Project	IEEE 802.16 Broadband Wireless Access Working Group < http://ieee802.org/16 >	
Title	Add new Data Path Management Primitives	
Date	2006-11-12	
Submitted		
http://wirelessman.org	ZTE corporation	jqian@zte.usa.com
/Source(s)		chuang@zte.usa.com
		xu.ling@zte.com.cn
Re:	Contribution on comments to P802.16g-D5	
Abstract	In this contribution, we propose to add Data Path Management Primitives to support both Data Path Management Service and MBS Service	
Purpose	Adoption	
Notice	This document has been prepared to assist IEEE 802.16. It is offered as a basis for discussion and is not binding on the contributing individual(s) or organization(s). The material in this document is subject to change in form and content after further study. The contributor(s) reserve(s) the right to add, amend or withdraw material contained herein.	
Release	The contributor grants a free, irrevocable license to the IEEE to incorporate text contained in this contribution, and any modifications thereof, in the creation of an IEEE Standards publication; to copyright in the IEEE's name any IEEE Standards publication even though it may include portions of this contribution; and at the IEEE's sole discretion to

Figure xxx C-DP-REQ/RSP/ACK (Create) Network Initiated

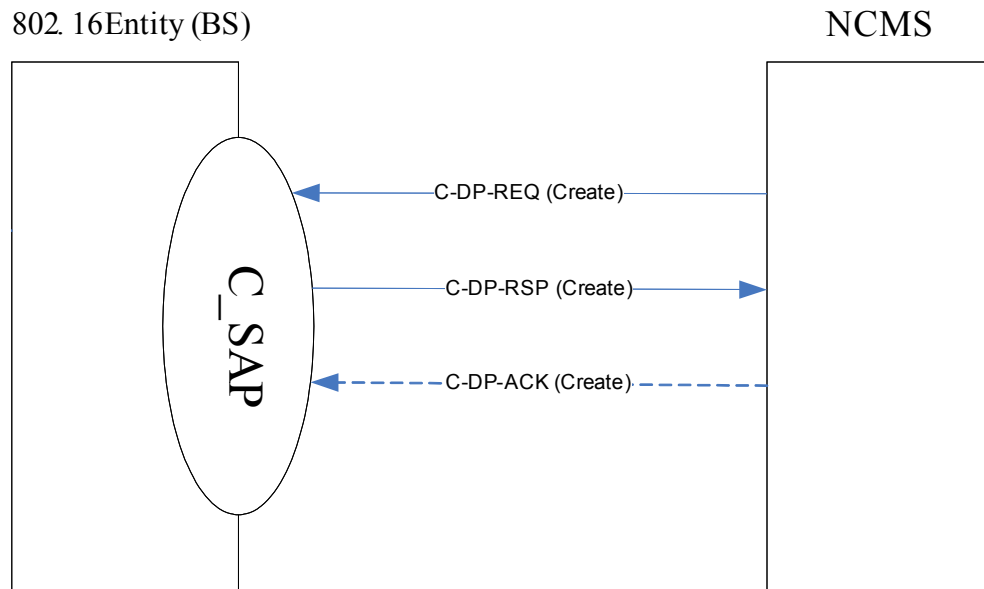
Data Path Management is used for create/modify/delete data path among corresponding network entities. These data paths are data bearer links between BS and NCMS. It will be mapped to radio connection (s) and data path (s) when a service is initiated or handover has happened. The Data Path Management Primitives are a set of primitives for supporting Data Path management between BS and NCMS (access network). Data Path management primitives can either use 2-way or 3-way handshake style based on needs.
